November 24, 2021

Subject: Laurel Elementary School HVAC Replacement
San Mateo - Foster City School District
Aedis Project No. 2021005.03
DSA Application #01-119551

ADDENDUM NO. 1

DATE 11/24/2021
JOB # 2021005.03
SHEET # AD-1
E3.1

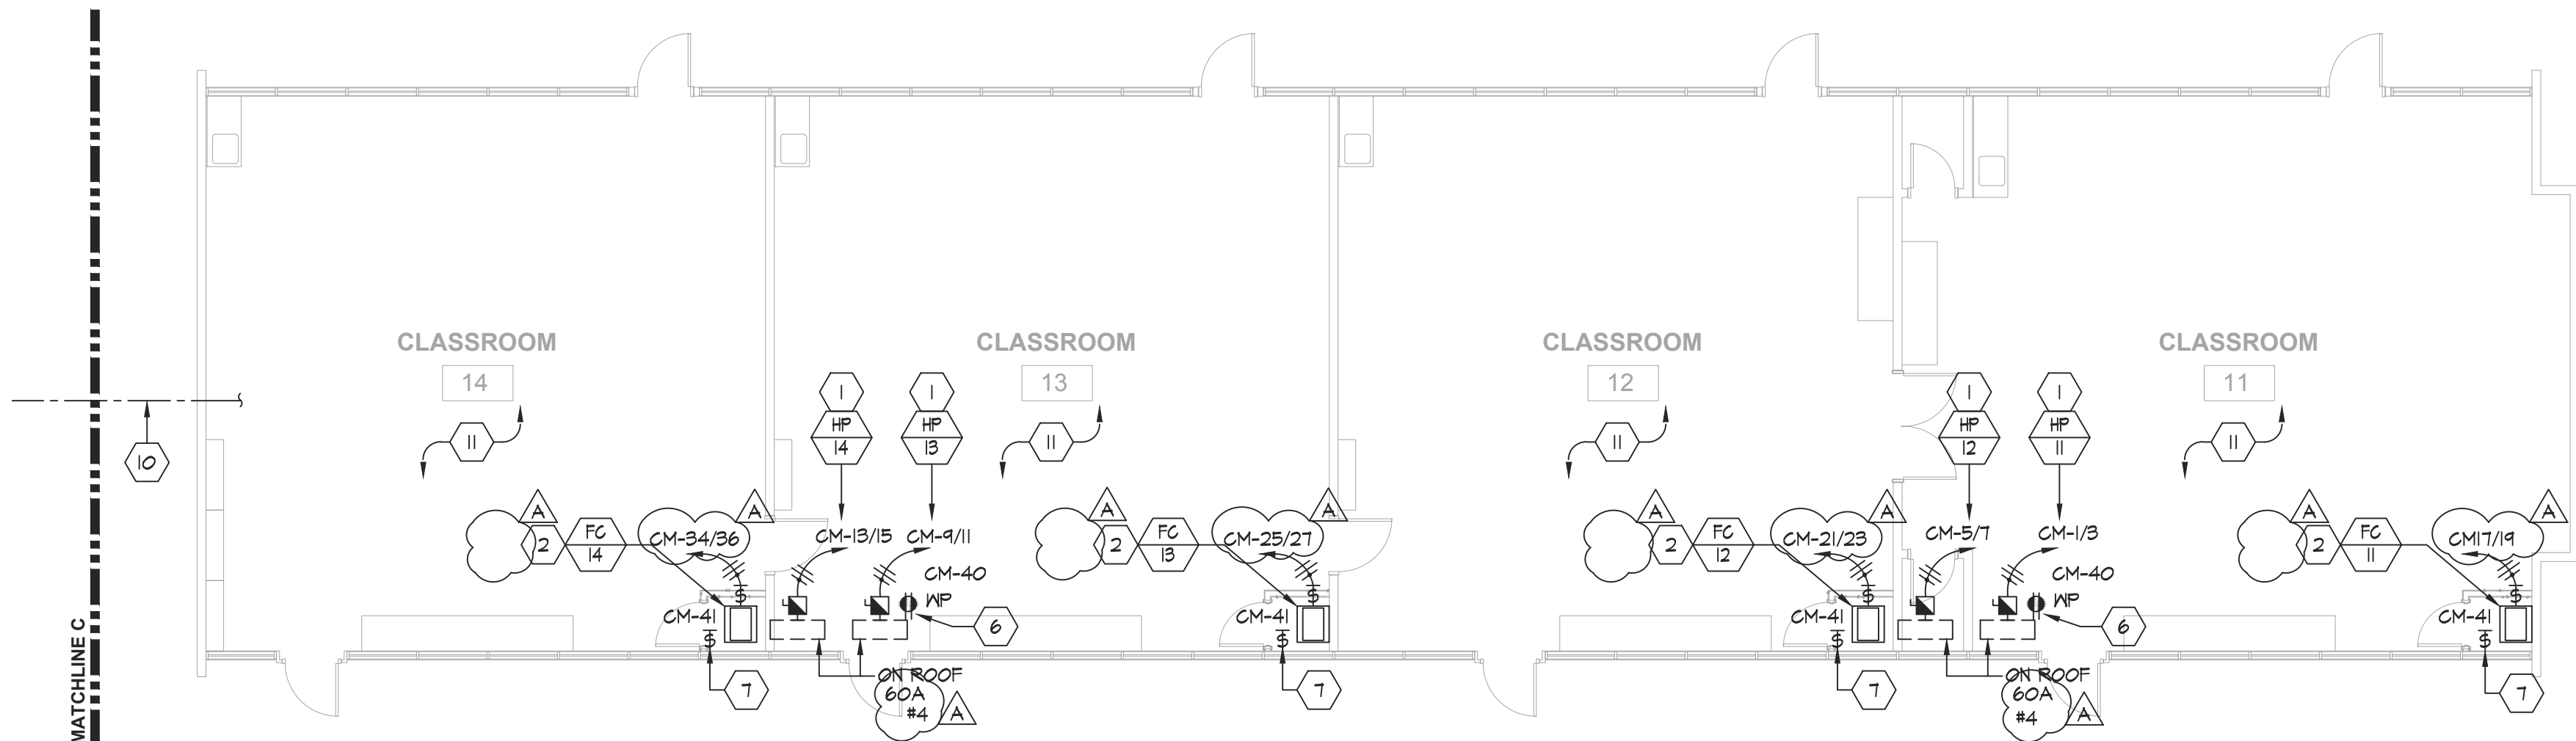
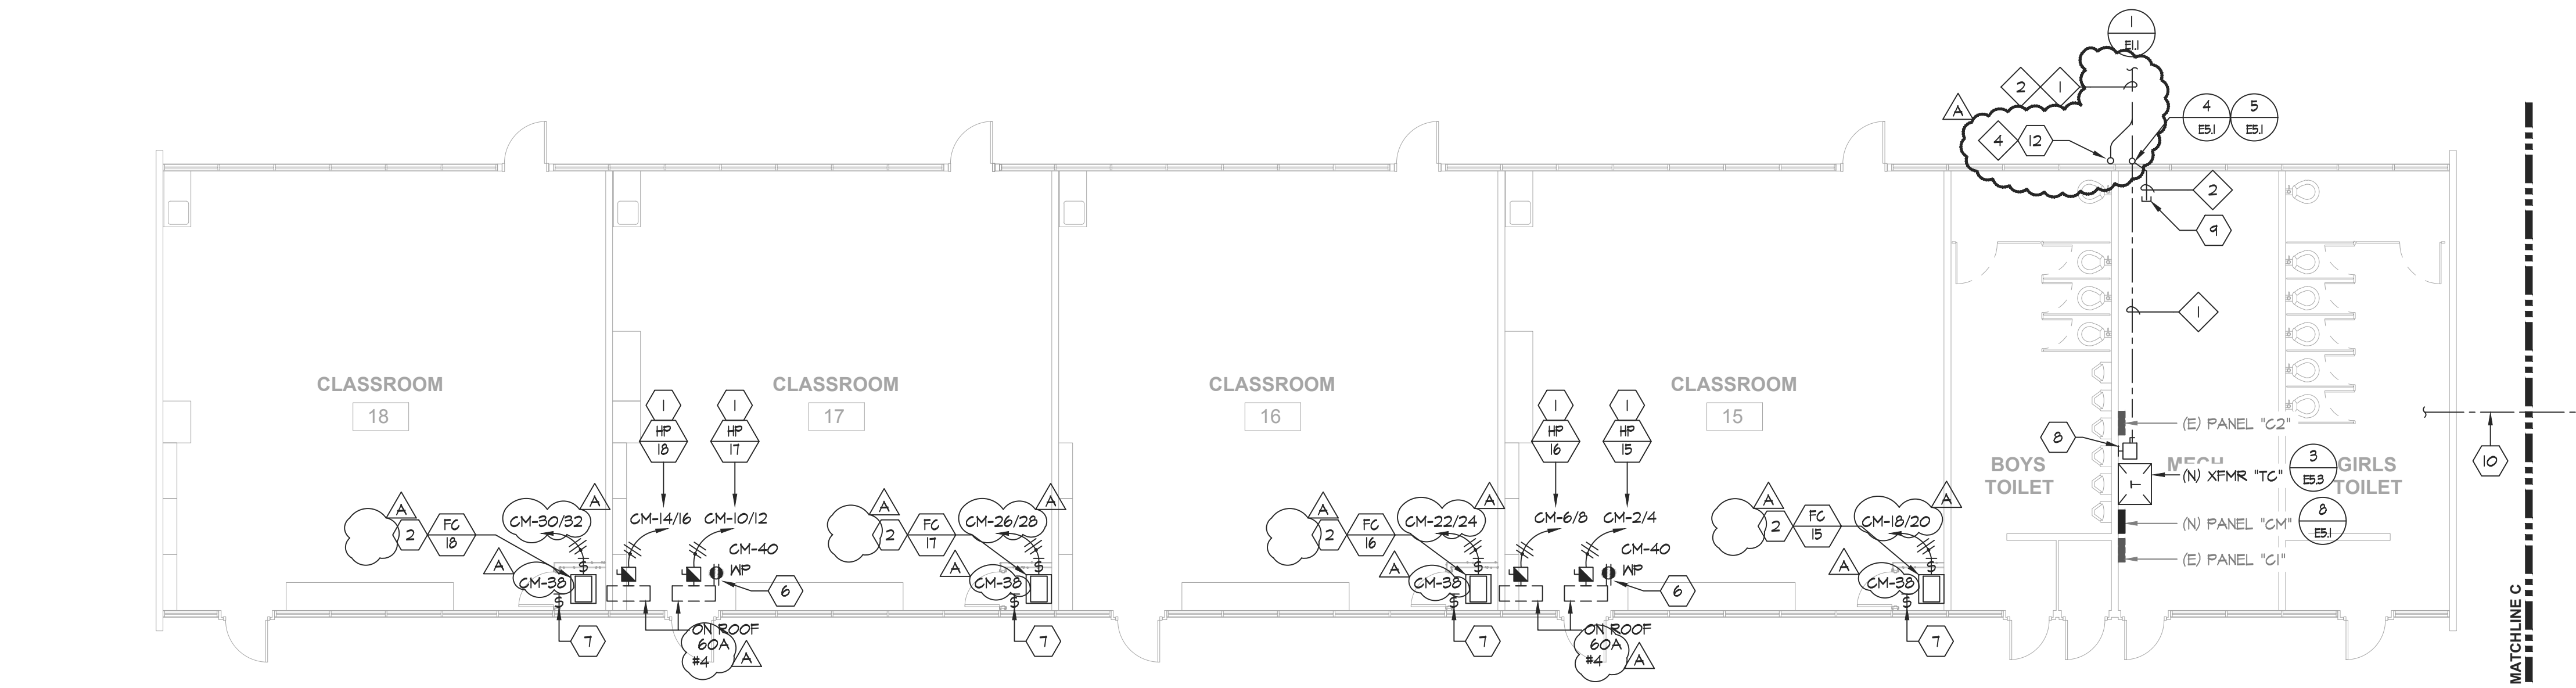
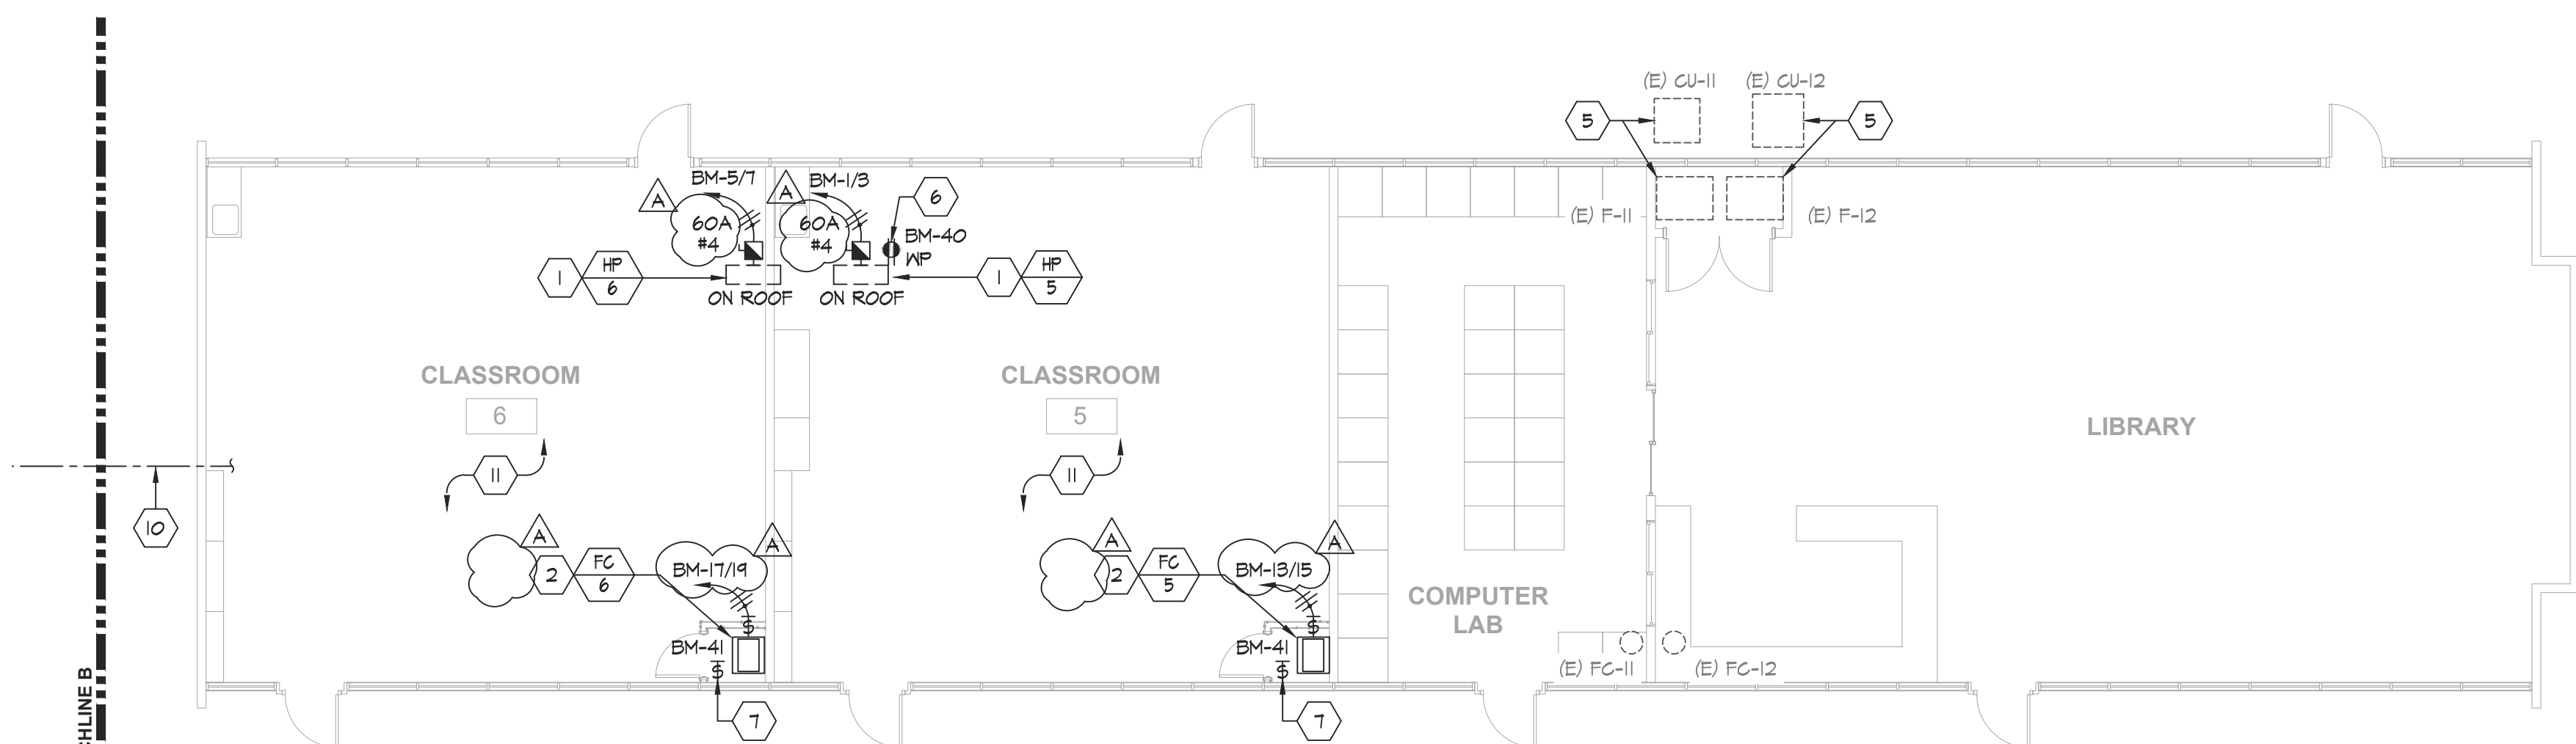
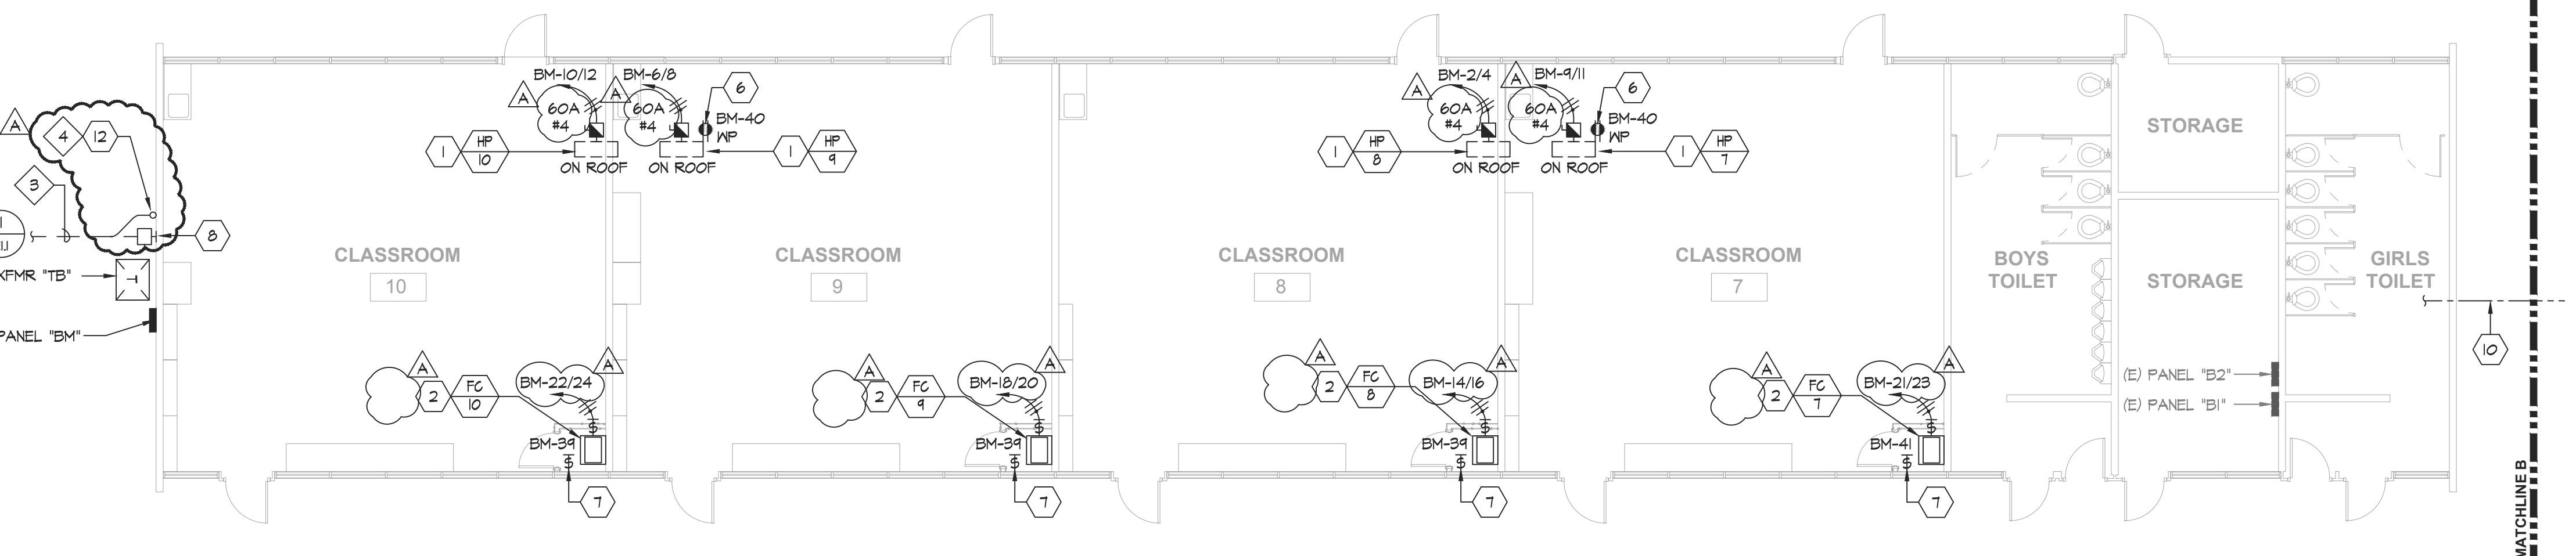
Add: General Note #7 per AD1-E3.1
Add: Sheet Note #12 and #13 per ad1-E3.1
Add: Conduit Tag #4 per AD1-E3.1
Add: Solar Conduit stub ups at each wing per AD1-E3.1
Revise: Sheet notes #1, #2, and #4 per AD1-E3.1
Revise: Classroom power plans per AD1-E3.1

ELECTRICAL NEW
FLOOR PLANS -
BLDGS A

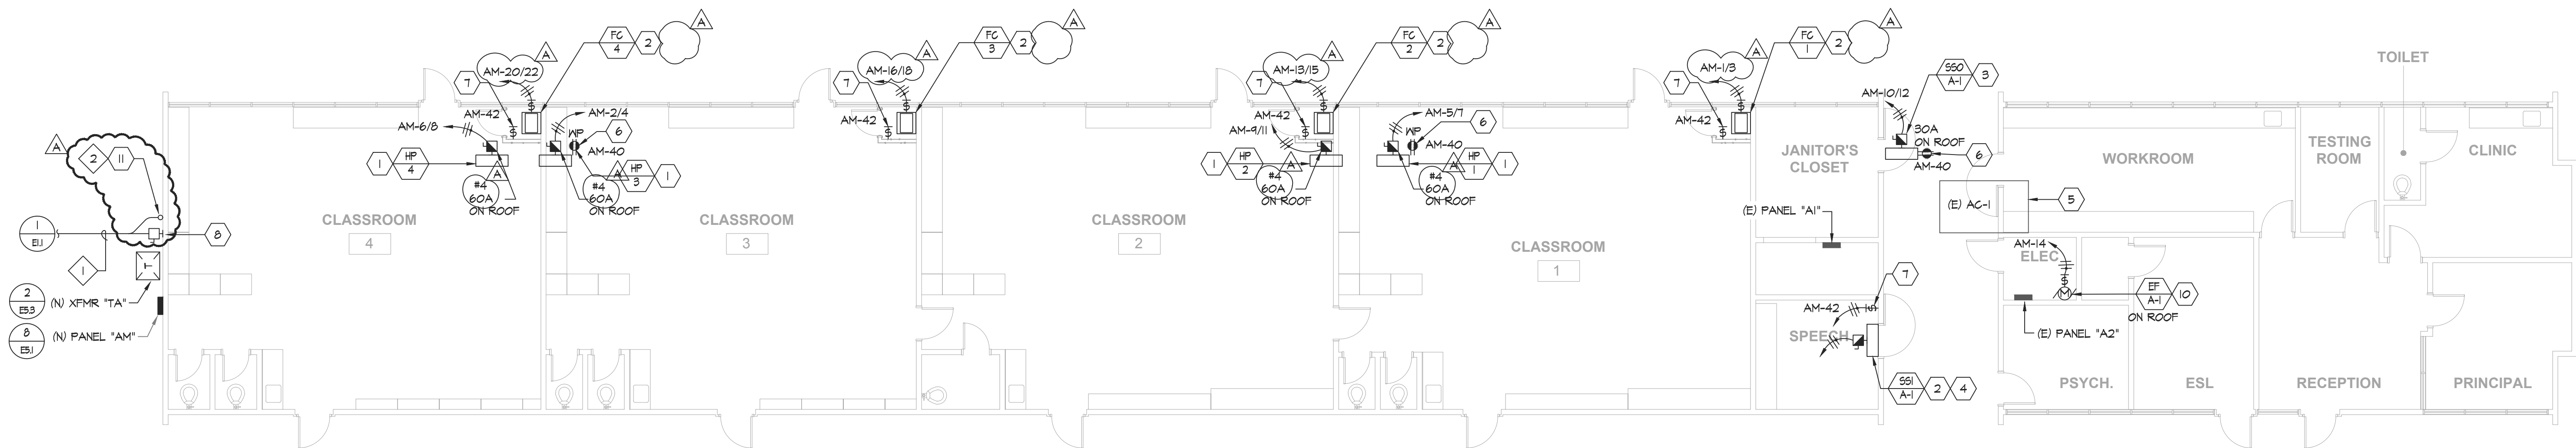
Add: General Note #7 per AD1-E3.2
Add: Sheet Note #11 per AD1-E3.2
Add: Conduit Tag #2 per AD1-E3.2
Add: Solar Conduit stub ups at each wing per AD1-E3.2
Revise: Classroom power plans per AD1-E3.2
